Appln no. 10/668,410 Amendment dated April 14, 2005 Response to Office Action of Oct. 20, 2004

Inventor: CULLER ET AL.
Title: STRUCTURED ABRASIVE ARTICLE (as amended)
Serial No.: 10/668,410

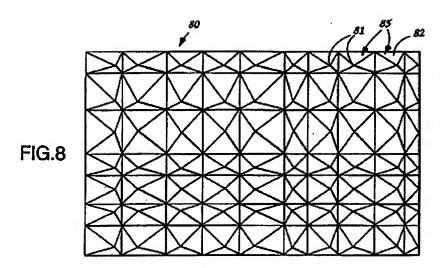
Reproduced below is FIG. 8 from Hoopman. FIG. 8 illustrates an abrasive article 85 with abrasive composites 80 having faces 82 and apex 81. Applicant agrees that some of the composites 80 have an apex 81 that is offset from the center of the composite base. However, as can be seen in FIG. 8, the offset of the distal regions is random, and the sum of the vectors of the offset does appear to approach zero.

The pending claimed invention differs from the teachings of Hoopman, including the illustration of FIG. 8, in that the pending claims recite that "the offset vectors for the plurality of protruding units do not exhibit a sum that approaches a limit of zero" (see claim 1, lines 10-11; claim 9, lines 10-11). There is no discussion in Hoopman of having the sum of the offset vectors not approach a limit of zero.

The first attached sheet of drawings includes changes to FIG. 4A. This sheet, which

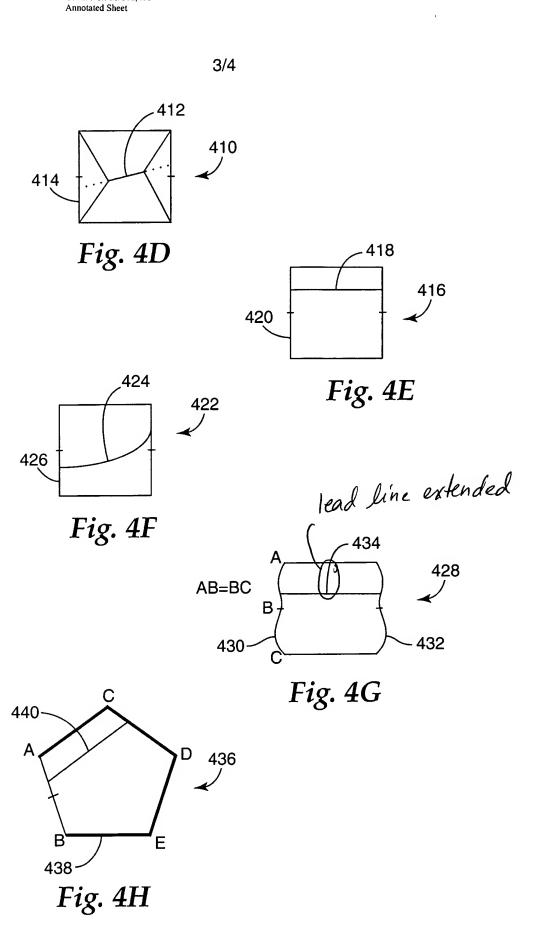
includes FIGS. 4A, 4B and 4C, replaces the original sheet. In FIG. 4A, reference numeral "406"

has been corrected to "403" to designate a composite side, and reference numeral "406" has been

added to designate the linear apex.

Fig. 4B

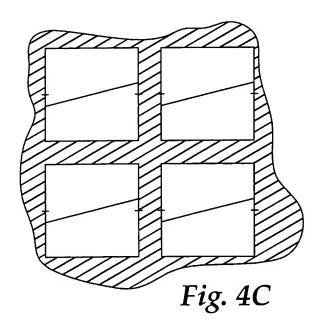
Additionally, in Figure 4A, reference numeral "406" has been corrected to "403" to designate a composite side, and reference numeral "406" has been added to designate the linear apex. In Figure 4G, the lead line for reference numeral 434 has been extended to the linear apex.
